Staff Report to the Board of Architectural Review Brixx Development Self-Storage Project

Hearing Date:	March 25, 2021
File Number:	L20-0059 Staff Report
Associated Permits:	E20-0008 - SEPA L20-0024 - Special Permission: Parking Determination L20-0017 - Lot Consolidation
Applicant:	Brett McDonough, Brixx Development
Request:	Construct a commercial storage building with associated roads, utilities, and half-street frontage improvements along S 143rd Street and S 143rd Place.
Location:	Address: 14300 Interurban Ave S Tukwila, WA Parcel Numbers: 336590-1655, -1680, -1685, 1690; and 000280-0007
Comp Plan and Zoning Designation:	Commercial/Light Industrial (CLI)
Environmental Review:	Determination of Non-Significance provided March 11, 2021.
Public Notice:	Notice of Application was posted on site and mailed to surrounding property owners, tenants, and agencies with jurisdiction on October 1, 2020. Notice of BAR public hearing was posted onsite and mailed to property owners and tenants within 500 feet of the property and agencies with jurisdiction on March 11, 2020.

Fig. 8: Site circulation patterns; vehicle access point in red, pedestrian access in blue.

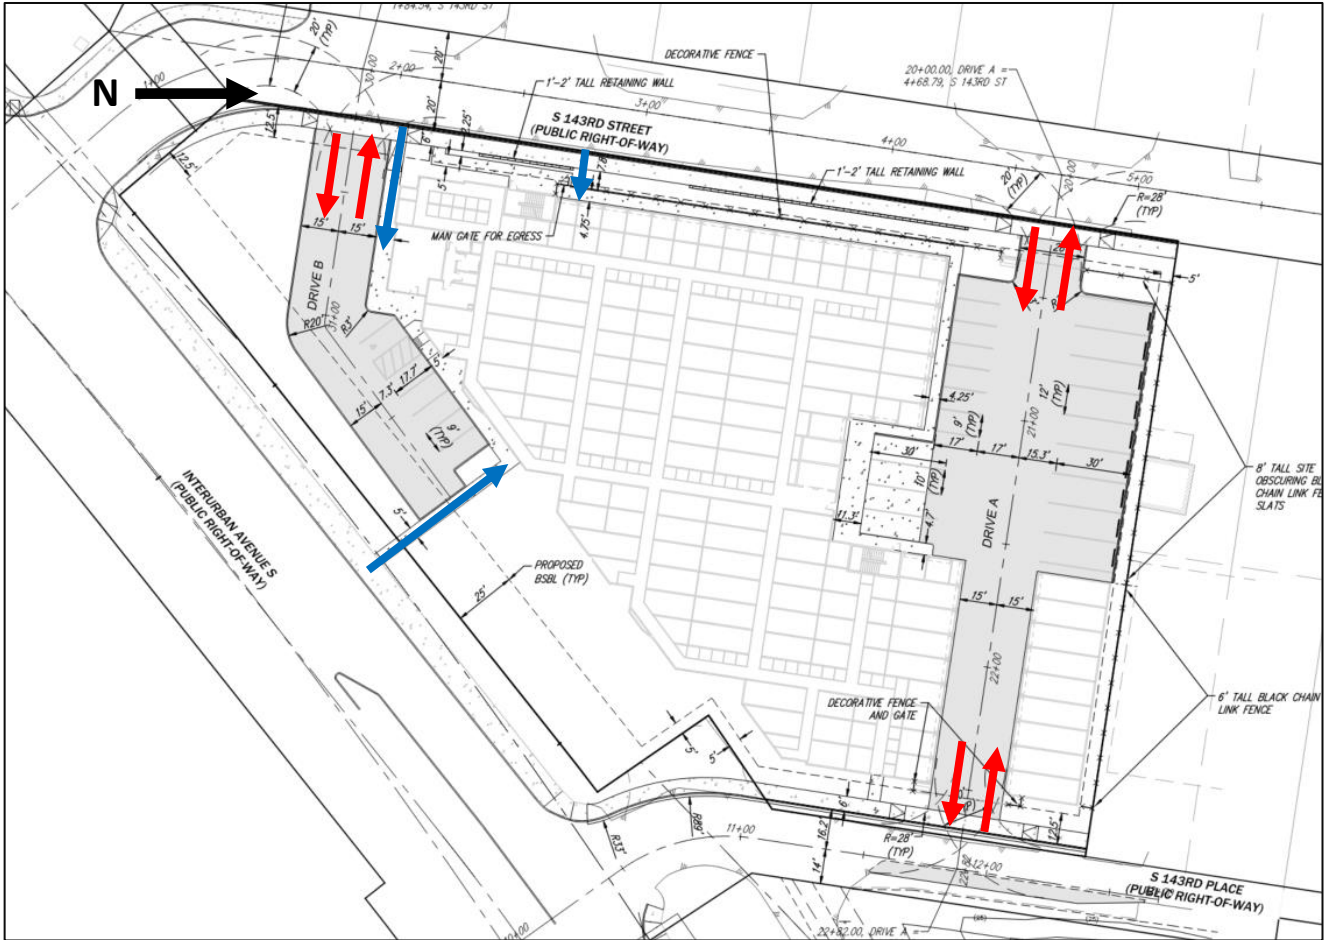
Vehicle access into the site is provided at three points, see below. Access to the main loading area is set to the east away from the intersections of Interurban Ave S to reduce potential vehicular conflicts, see Fig. 8.

Fig. 9: Landscaping areas impacted by sidewalks (blue), additional landscaping provided (green).

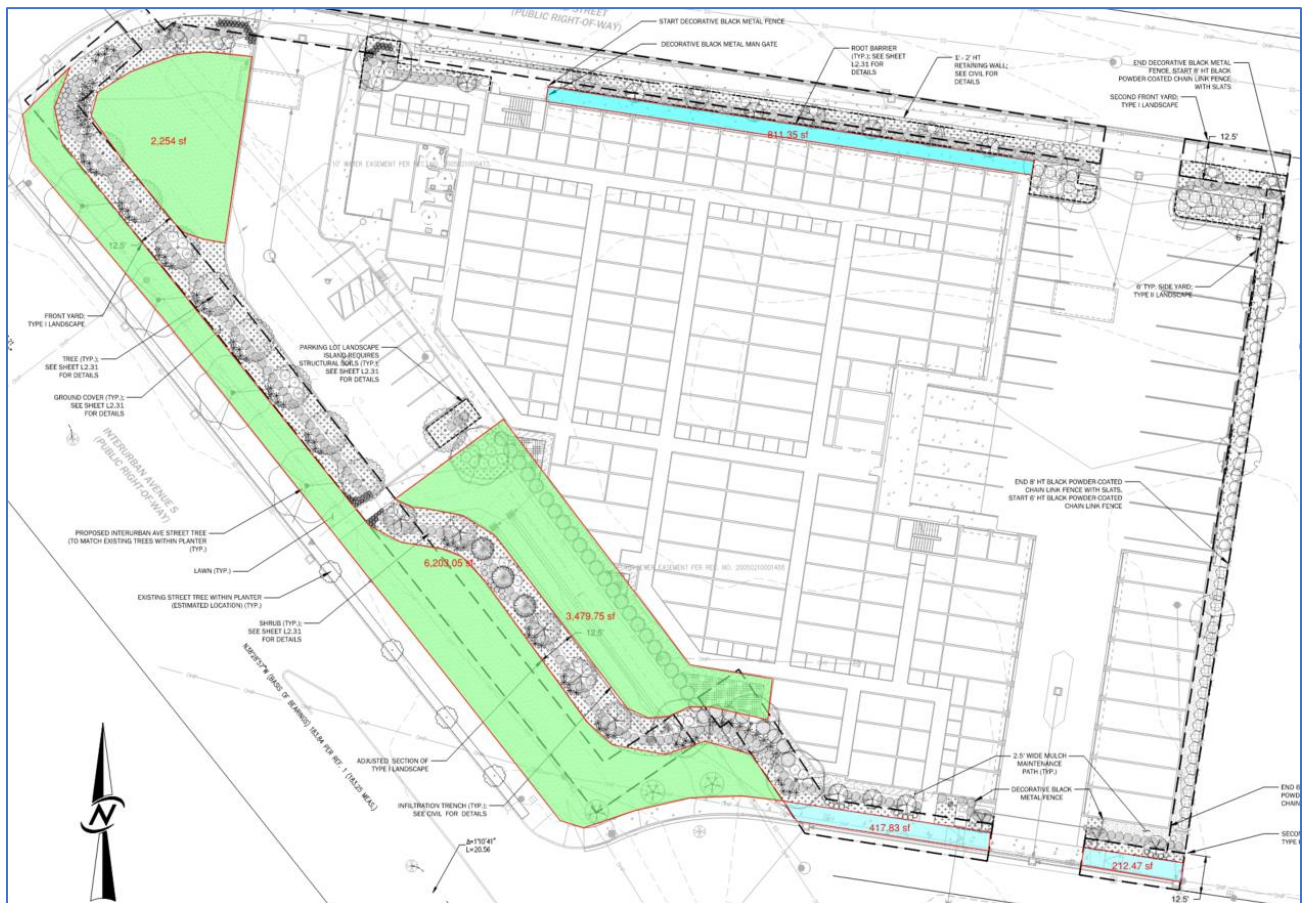
The site fronts three streets, increasing the setback area overall and reducing the amount of developable area. As a result, the 5' wide pedestrian access into the site from S 143rd St and the public sidewalk provided along S 143rd Pl is located within the required 15' landscaping areas. To continue to meet the requirements for overall landscaping area, the project will cluster the amount of landscaping compromised by the pedestrian access, approximately 1,400 sf, and locate it elsewhere on site. Approximately 12,000 sf of additional landscaping area has been provided as a result (Fig. 9). The requirements for Type I landscaping within the remaining 10' wide landscaping area will still be met otherwise.
